EA Submissions Response Apex Energy Project Application No: 07_0103

Jointly Prepared by Apex Energy NL, EcoEngineers Pty Ltd, Biosis Research Pty Ltd and Olsen Consulting Group Pty Ltd

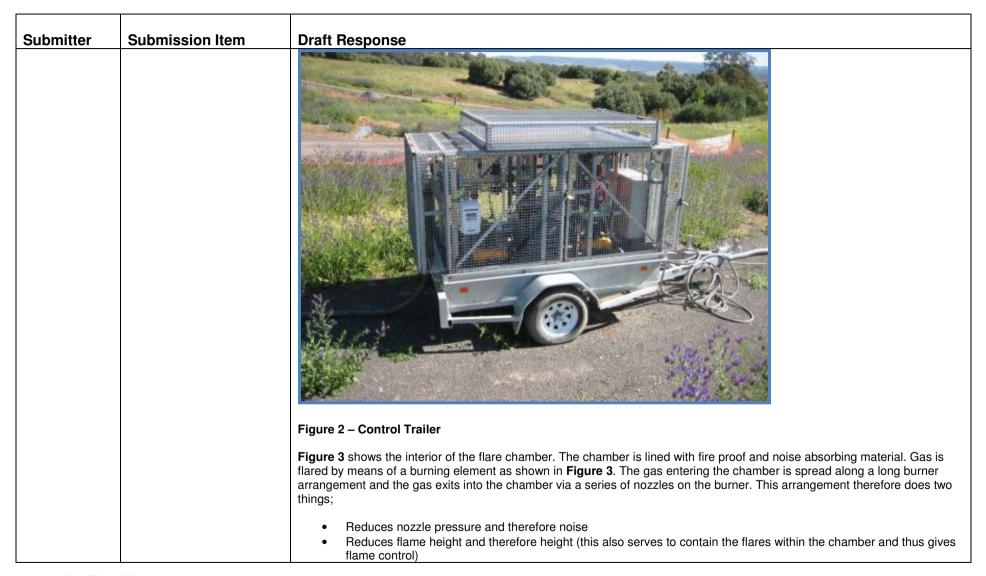
Submitter	Submission Item	Draft Response
Dr Ann Young.	3.6 Comments re p38 of EA. How quickly can flaring be stopped?	Flaring can be stopped instantaneously with manual valves and automatically operated valves that are designed to close during emergency fire events. The wellhead arrangements would be designed to withstand bushfire conditions. The proposed flaring unit is able to withstand fire and is designed to minimise the risk of fire escape.
		Apex recognises the risks associated with the exploitation of Coal Seam Methane and Coal Mine Methane. Apex's operational personnel are experienced drilling, mining and risk managers who have and will ensure that hazards are adequately identified and risks assessed and controlled. Apex recognises the need to work with the local community and local authorities such as the Rural Fire Service (RFS). Intensive liaison has already taken place between Apex and the RFS and this relationship will continue. Liaison so far includes RFS headquarters meetings, local meetings, liaison with local RFS personnel and an RFS presentation given by Apex to the Darkes Forest RFS personnel. Fire mitigation measures will also be developed by consultation with the Sydney Catchment Authority, the Department of Environment and Climate Change and the Department of Primary Industries.

Submitter	Submission Item	Draft Response
Capillites		Light Heat. Apex plans to use a purpose designed flare chamber to meet the needs of Apex whilst operating around the Illawarra. This type of flare chamber is currently used by AGL at Camden. The provision of such a facility will follow detailed HAZOP analysis to assist in the design. The HAZOP analysis will address a range of issues including the following: Transportability Visibility Fire risk mitigation Noise Controllability Safety devices Materials Training of personnel Maintenance Figure 1 shows a wide view of similar gas flaring facilities used near Camden.

Submitter	Submission Item	Draft Response
		Figure 1 – Wide view of Flare Box and Control Trailer
		<u>Description of General Facilities</u>
		Flame control will be via an external and separate control facility as shown in Figure 2 . This trailer arrangement contains the ignition control, flame arrestors, shut down facilities and indeed all the facilities needed to make the facility fully controllable remotely. This arrangement allows for the ignition of the facility manually and automatically to comply with legislation and the ability to shut down the flare automatically or manually.

Submitter	Submission Item	Draft Response
		Therefore in summary, these flare facilities are designed through engineering and environmental risk management and provide remote controllability. However, no flare will be lit whilst the facility is unattended and continuous liaison with the Rural Fire Service will take place during operations.
		Figure 3 – Interior of Flare Chamber
